SERVICE INSTRUCTION

RUNNING MODIFICATIONS ON ROTAX[®] 2-STROKE UL AIRCRAFT ENGINES SI-2ST-004

Running modifications on ROTAX[®] 2-stroke UL aircraft engines.

View: Rotary valve drive 582 UL
Fig.: 1 and 2

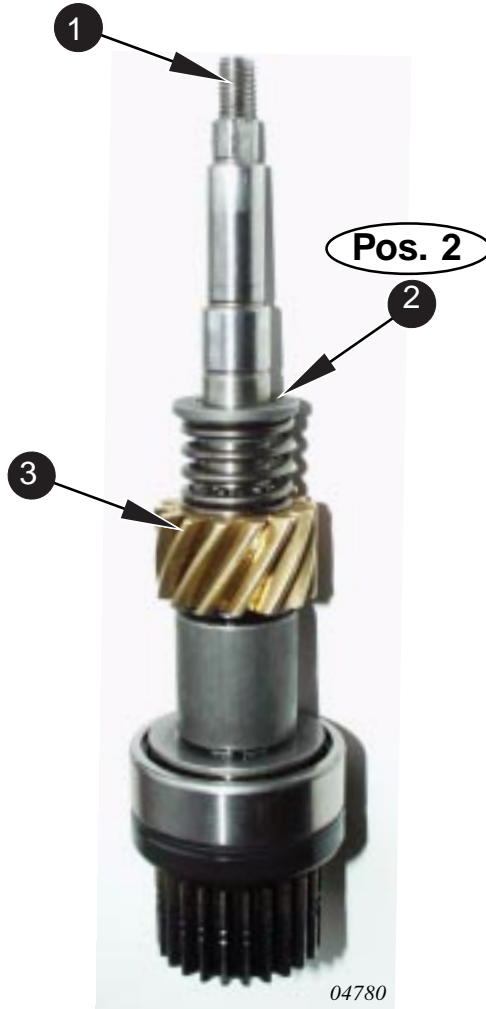
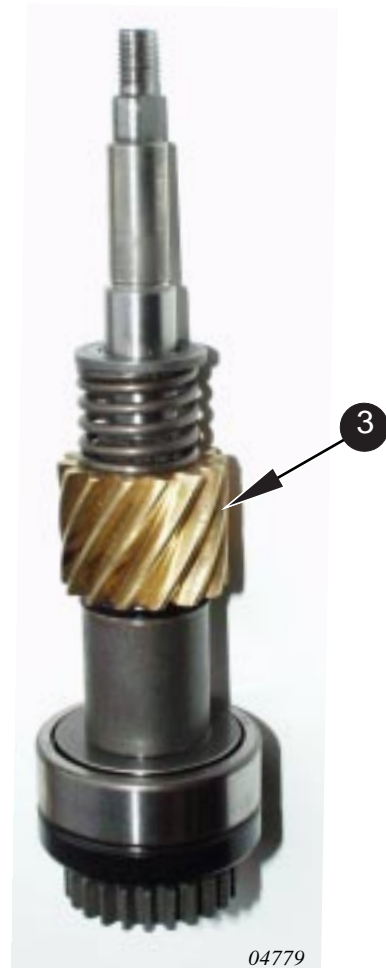
By reason of standardization a new rotary valve shaft unit has been introduced on the 582 UL mod. 99.

The new rotary valve shaft (1) part no. 837 243 has two grooves for fixing the rotary valve shaft components.

■ **CAUTION:** At assembly of the rotary valve shaft components make sure to fit circlip (2) part no. 845 160 in the second groove of the rotary valve shaft (thus reaching a higher pretension on the rotary valve (3)). In the first groove, utilized on other engine types, no circlip shall be fitted!

Bild / Fig. 3

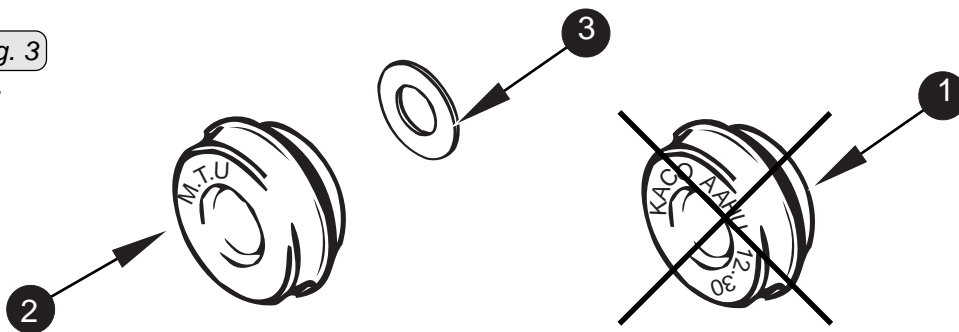
Owing to further development and standardization of parts the rotary valve seal (1) part no. 850 940 has been replaced by the rotary valve seal (2) part no. 850 942 along with an additional shim (3) part no. 944 382.

■ **CAUTION:** Because of the shorter design the new rotary valve seal (2) has to be fitted along with the shim (3).

Bild / Fig. 4

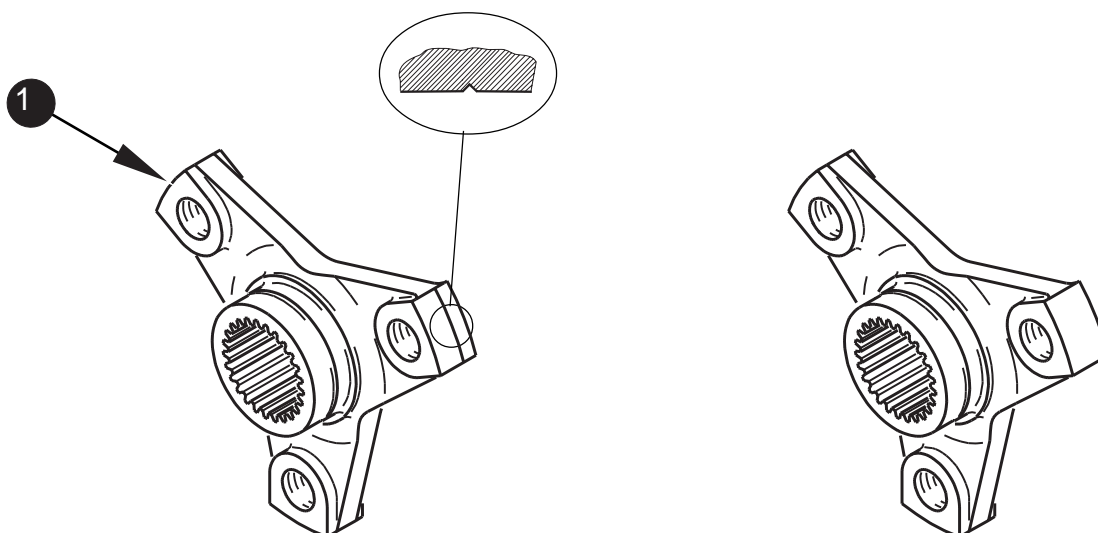
Owing to continuous refinement of the gearbox sealing a new combination of coupling flange (1) part no. 958 971 and oil seal (2) part no. 950 084 has been introduced.

■ **CAUTION:** A combination of components of old and new design must not be fitted i.e. the new type of coupling flange (1) with identification groove may only be fitted together with the new oil seal (2) part no. 950 084.

◆ **NOTE:** Commencing with production code O6 new sealing components has been introduced in serial production. The gasket set for the reduction gearbox type „C“ and „E“ contains the new oil seal (2) part no. 950 084, only.
